From: Mueller, Stephen D - DNR
To: Jay Karls; mwilliams@whdlaw.com
Cc: Mueller, Stephen D - DNR
Subject: RE: Regal Products
Date: Friday, July 22, 2016 8:16:03 AM
Attachments: Conceptually proposed structural impediment boring locations.pdf
image001.png
image002.png

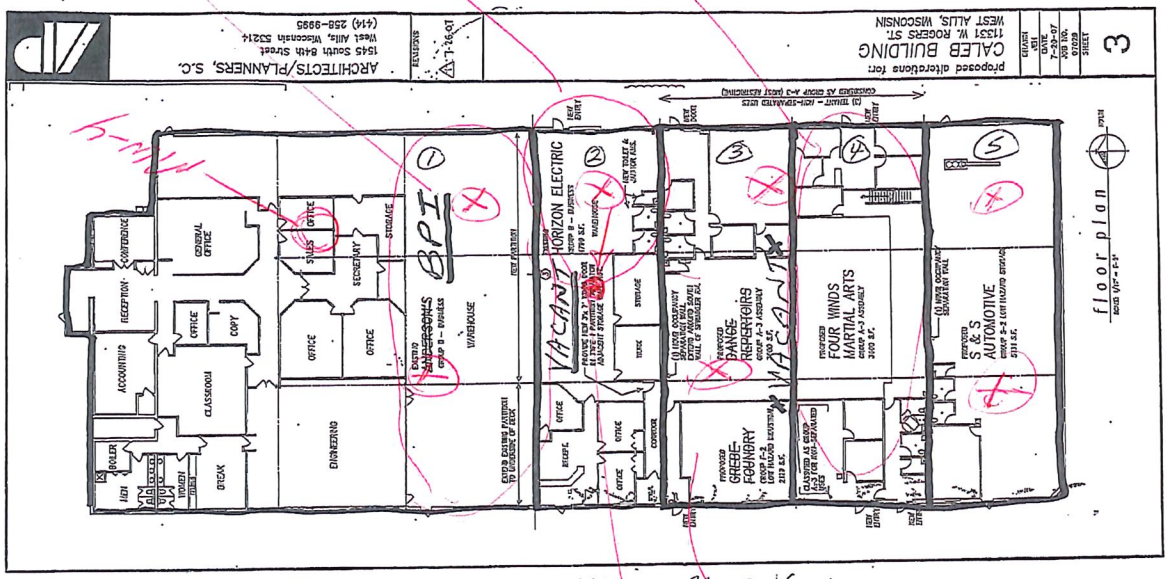
I'm thinking (with the hope of heading off VPLE Committee concerns) that a couple of borings (2-3) around the periphery of the northern third of the building (structural impediment) should be included in your work plan. I will attempt to convince the Committee to review the plan while I am gone. However, if that doesn't happen we will have to rush the review & approval when I get back. So, I suggest that you consider scheduling a driller for late August, or at least schedule an alternate (fallback) date then...
